**PAUL HALAJIAN
ARCHITECTS**

ADDENDUM

PROJECT: **Clovis Landmark Square
Senior Activity Center and Transit Center**

ADDENDUM#: **03**

PROJECT NUMBER: 17044.1
SHEET NUMBER: AD3 S505

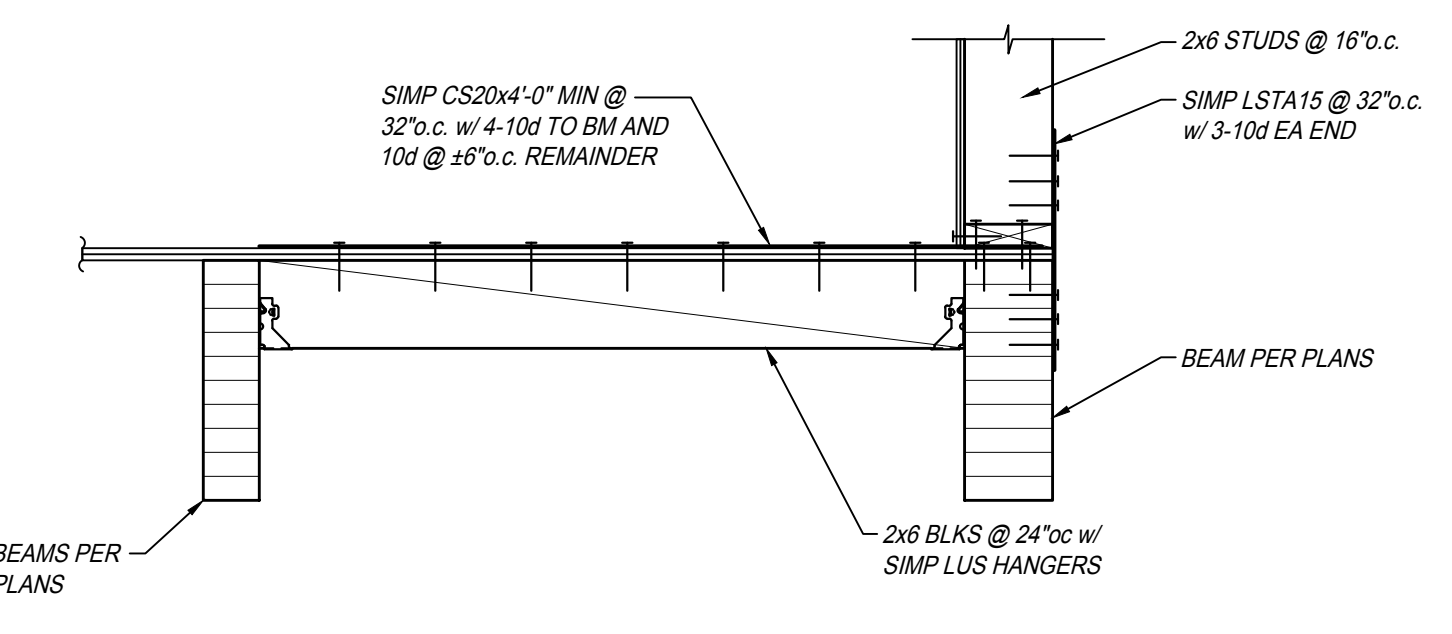
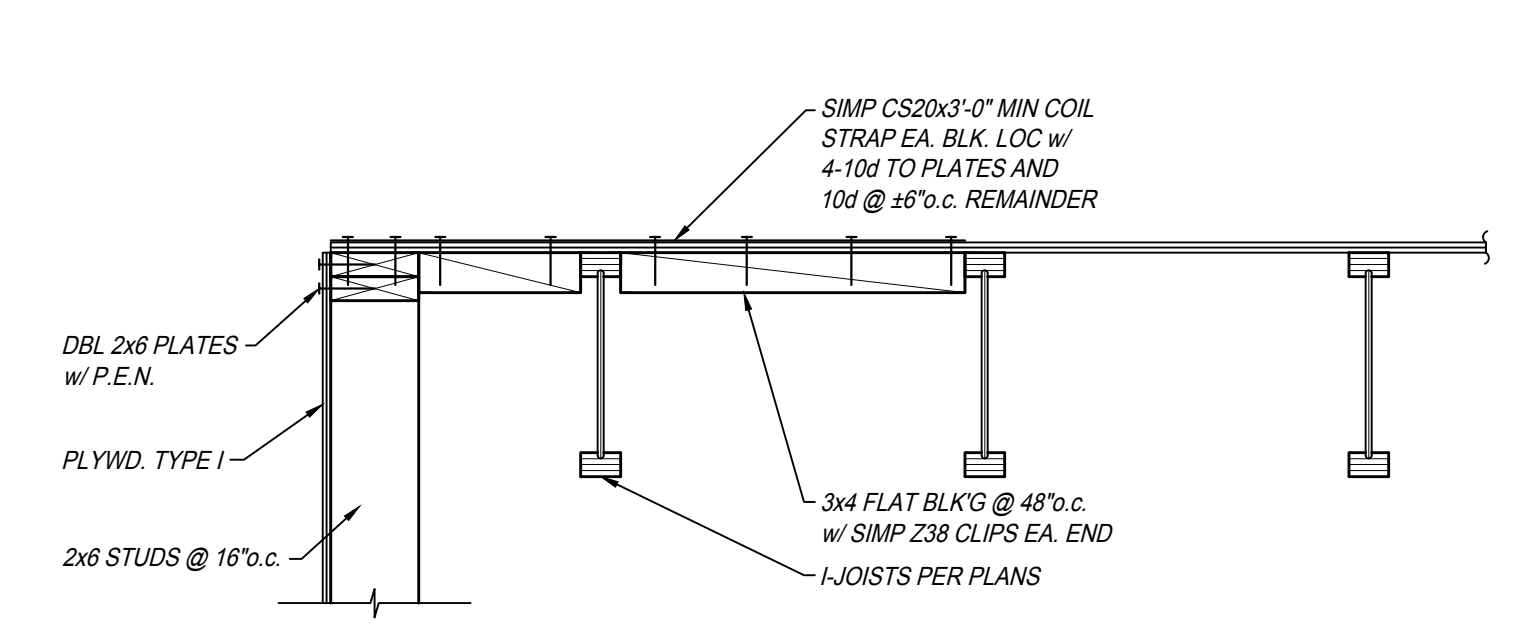
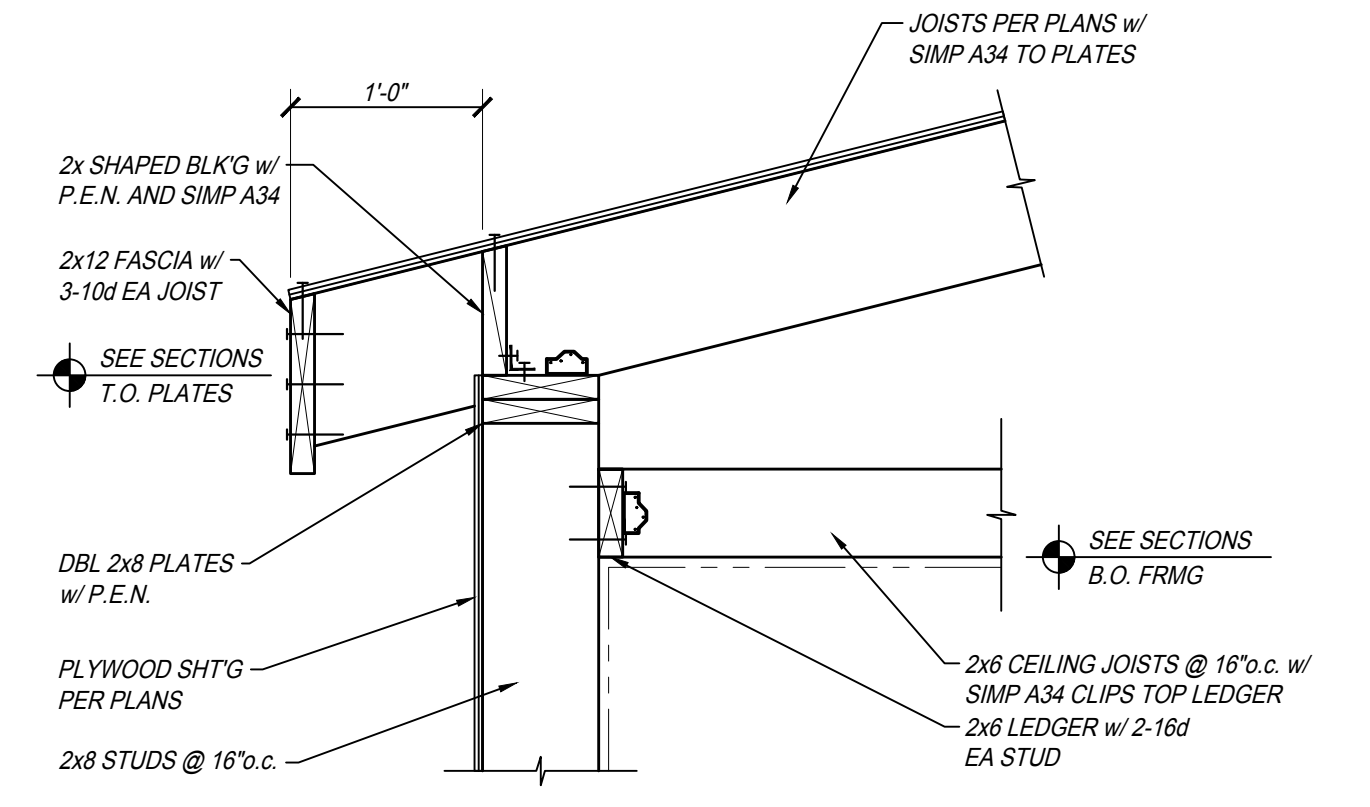
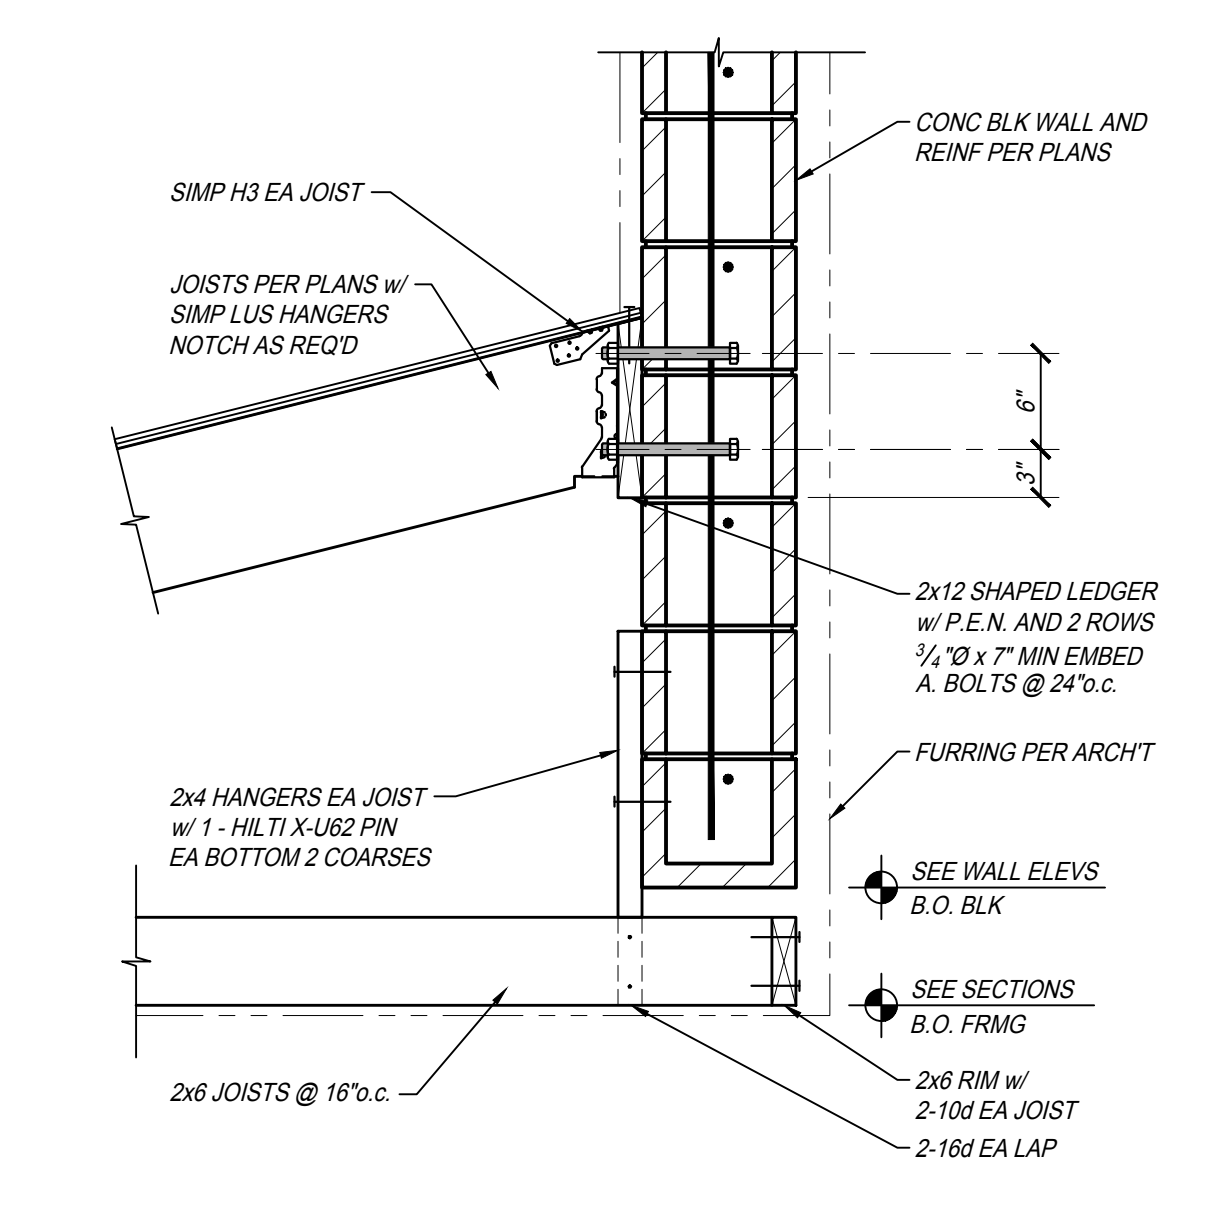
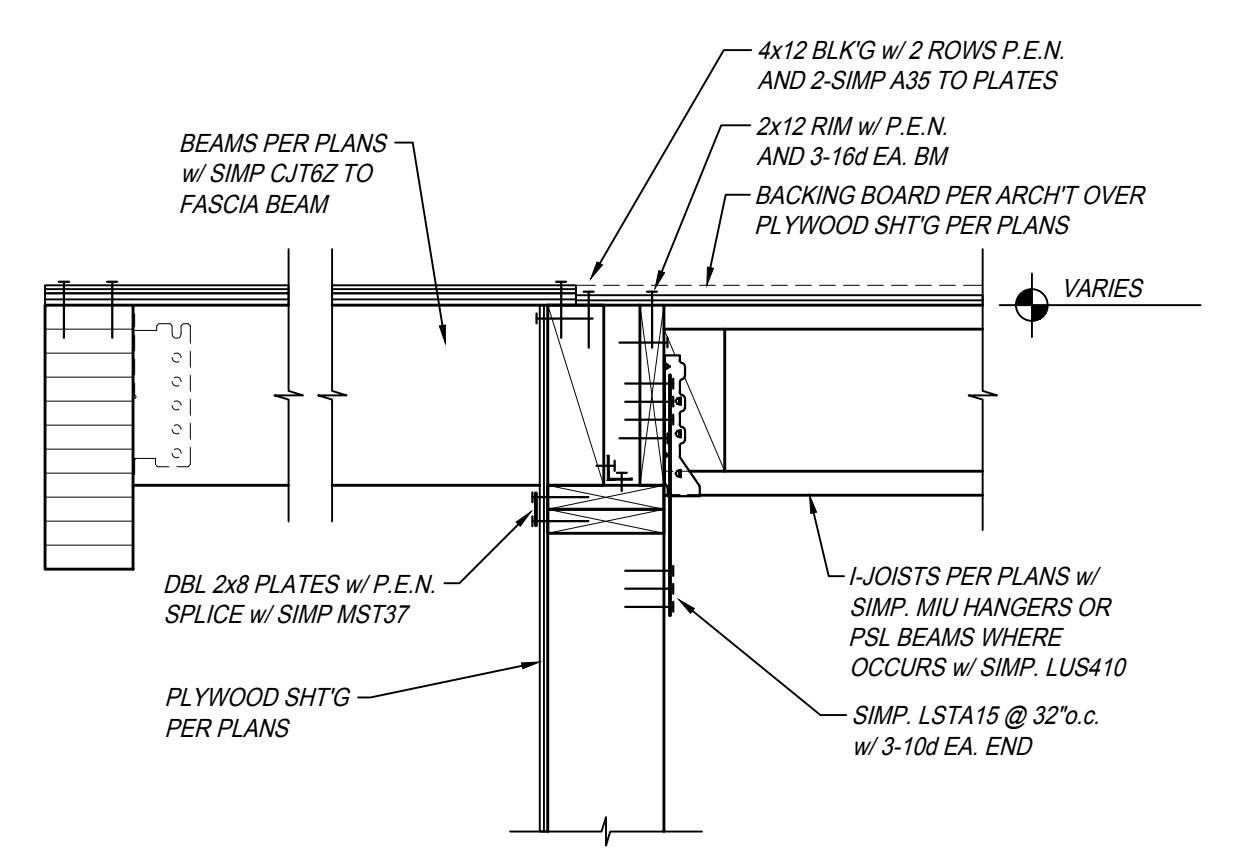
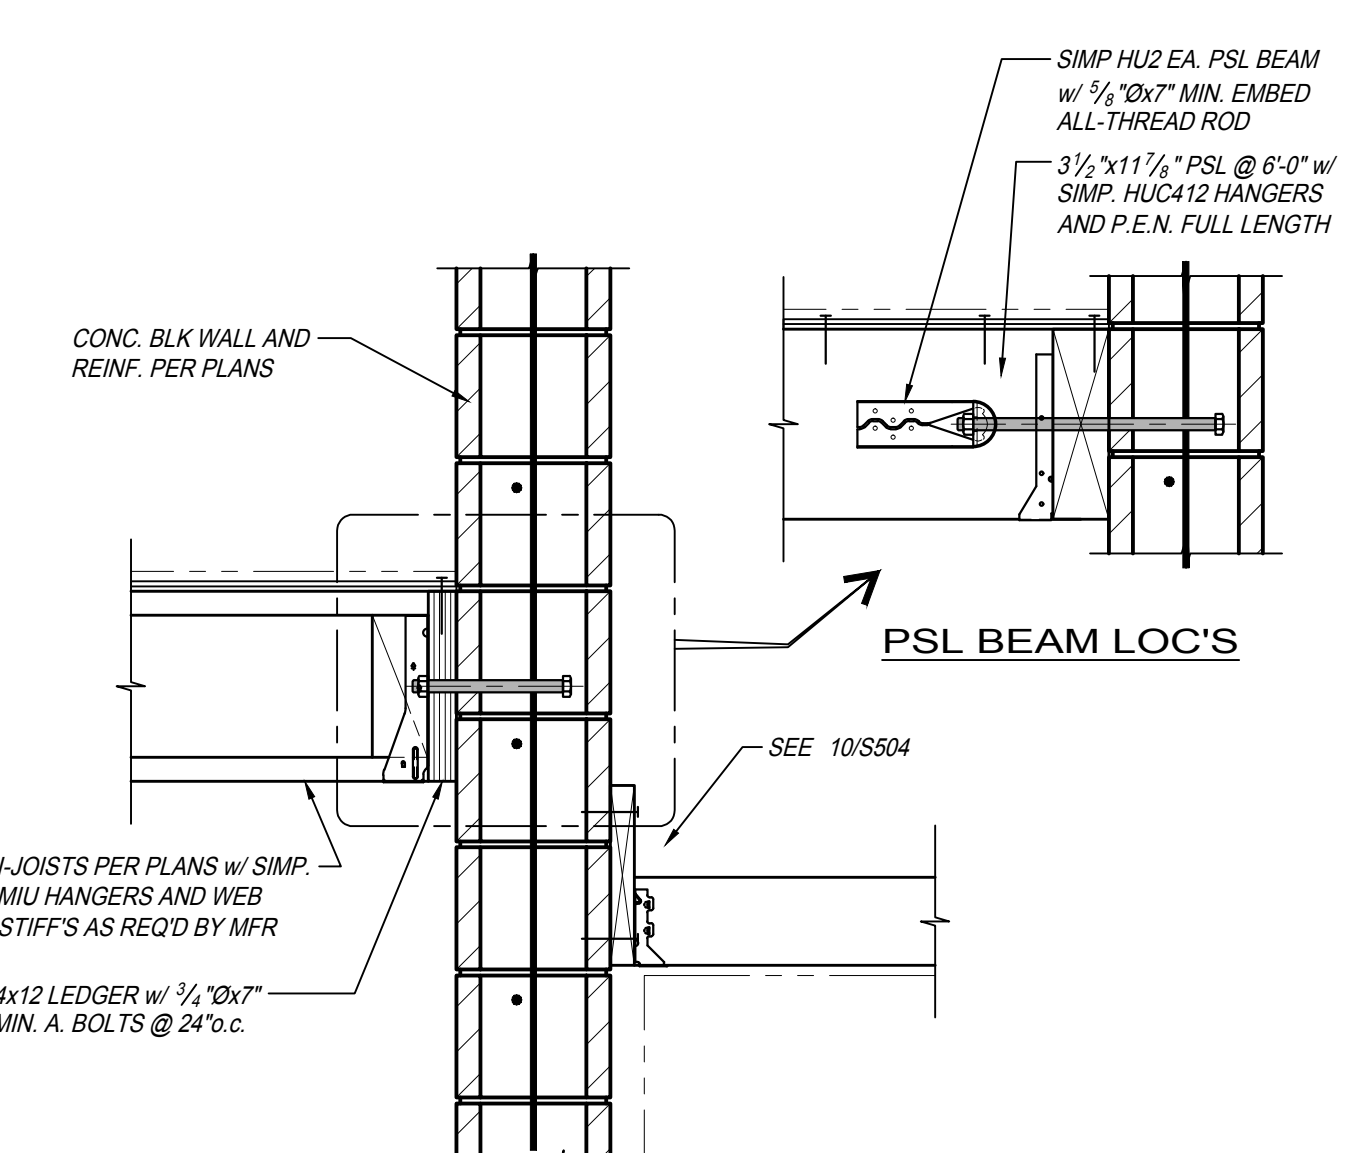
- a. Omit sheet **AD2-S505, Roof Framing Details** and replace with **AD3-S505, Roof Framing Details** attached. The following changes have been made:
 - i. Revised bolts at beams to All-Thread rods with heavy-hex nuts.
